Access Compliance Report

Public Rights-of-Way

(Curb Ramps)

Intersection ID: 13540	Main Street: LEXINGTON_AV	Cross Street: S_CALDWELL_ST	Location: E
ADA ID: 4D886B4309BC	Ramp Type: BlendTrans1	Initial Pass/Fail: Fail	Overall Compliance: No
Severity Score: 1.25			
Codes/Mitigation Info/Possible Solution		Field Measurements/Component Compliance

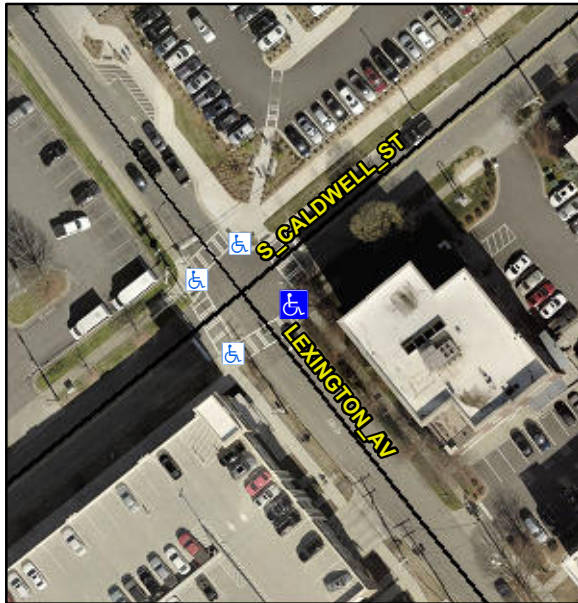
Compliance	Description	Data	Compliance	Description	Data
N/A	Ramp Length (in)	80.0	Yes	BlendTrans Slope (%)	3.5
Yes	Ramp Width (in)	84.0	No	BlendTrans XSlope (%)	2.7
N/A	Flare Type LT	N/A	N/A	Flare Type RT	N/A
N/A	Flare Slope LT (%)	N/A	N/A	Flare Slope RT (%)	N/A
N/A	Flare Traversable LT?	N/A	N/A	Flare Traversable RT?	N/A
N/A	Landing Length (in)	N/A	N/A	DWS Provided?	N/A
N/A	Landing Width (in)	N/A	N/A	DWS Contrast?	N/A
N/A	Landing Slope (%)	N/A	N/A	DWS Length (in)	N/A
N/A	Landing X Slope (%)	N/A	N/A	DWS Full Width?	N/A
N/A	Landing Curb? (Y/N)	N/A	N/A	DWS Offset (in)	N/A
N/A	Shared Landing?	N/A			
N/A	Gutter Ponding?	N/A	N/A	Gutter Slope (%)	N/A
N/A	Gutter Lip Ht (in)	N/A	N/A	Gutter X Slope (%)	N/A
N/A	Painted X Walk1?	Yes	N/A	Painted X Walk2?	Yes
	X Walk 1 Direction	To NW		X Walk 2 Direction	To SW
	X Walk 1 Width (in)	111.0		X Walk 2 Width (in)	112.0
	X Walk 1 Slope (%)	6.2		X Walk 2 Slope (%)	3.9
	X Walk 1 X Slope (%)	1.8		X Walk 2 X Slope (%)	4.6

N/A	Ramp inside XWalk1?	Yes	N/A	Ramp inside XWalk2?	Yes
	Road Slope (%)	2.6		Clear Space?	N/A
	Road X Slope (%)	6.5	N/A	Clear Space to XWalk (in)	N/A
N/A	Any Obstructions?	N/A	N/A	Storm Grate/Utility Hazard?	N/A
	Obstruction Type			Storm Grate/Utility Type	
		N/A			N/A
			Yes	Surface Condition? (G/P)	Good
			N/A	Curb Slope (%)	1.2

Remove & Replace Curb Ramp With Two New Directional Ramps or Equivalent.

R304.5.3
